From: "joel" <joel@advancedburner.com>
To: "Phil Hailes" <Phil-H@ipsc.com>
Date: 8/11/2003 4:21:23 PM
Subject: Re: IPSC Low NOx Burner Spec Attachments

From: "Phil Hailes" <Phil-H@ipsc.com>
To: "Phil Hailes" <Phil-H@ipsc.com>
Sent: Monday, August 11, 2003 5:36 PM
Subject: IPSC Low NOx Burner Spec Attachments

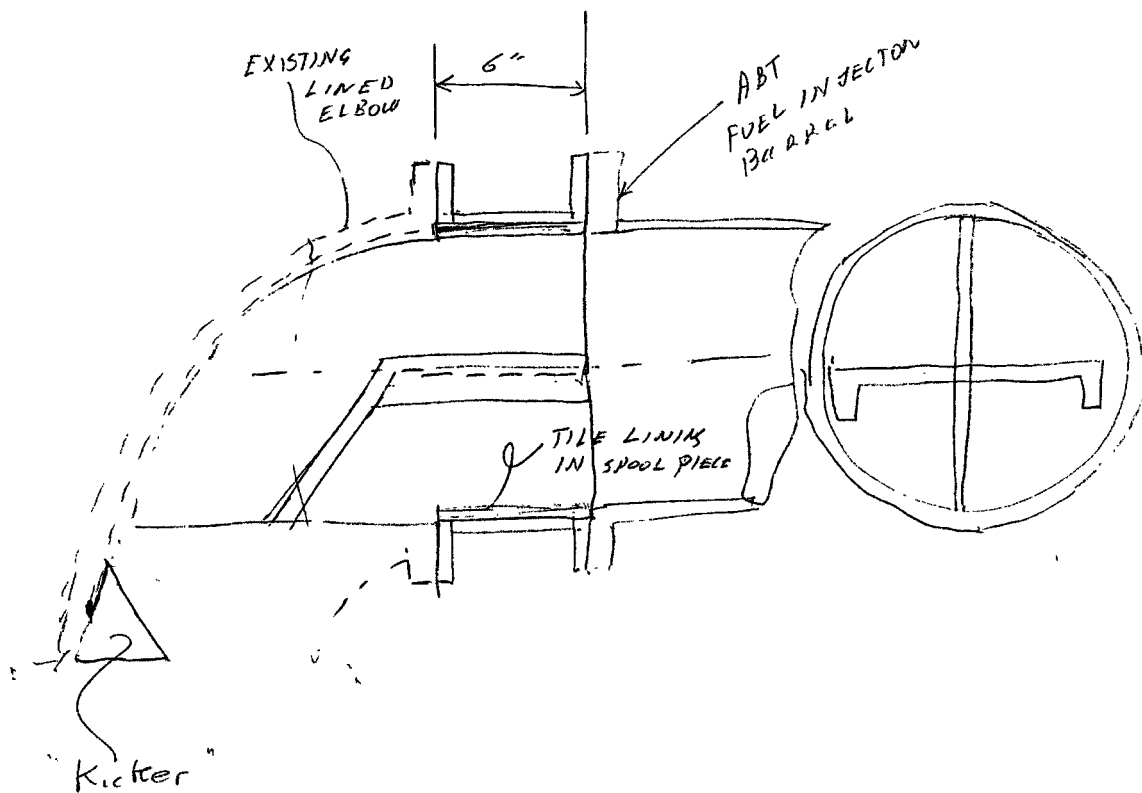
Attached is a hand sketch showing a 6" wide flanged pool piece, lined, to which the X-vanes are attached. This is first bolted to the elbow and becomes one ass'y, which is then bolted to the fuel tube (made 6" shorter). Taking into account the shipping and shop savings we would accrue, there is an additional cost of \$850.00 per burner. However, it has the advantage of giving the performance we want while keeping the elbow and X-vanes separate (similar to what we do with the flatback elbow, except in this case we do the attachment from the outlet end rather than the back). The kicker can be field installed. We are checking with our fabricator to see if they can send two of their people out to do this, rather than rely on the field labor.

If you prefer to have the elbows completely relined, our shop can do it within the same two week period allotted. The additional cost is \$1000.00 per burner.

We can go either way. If the elbows have additional life it may not be necessary to reline them now. But this is your call.
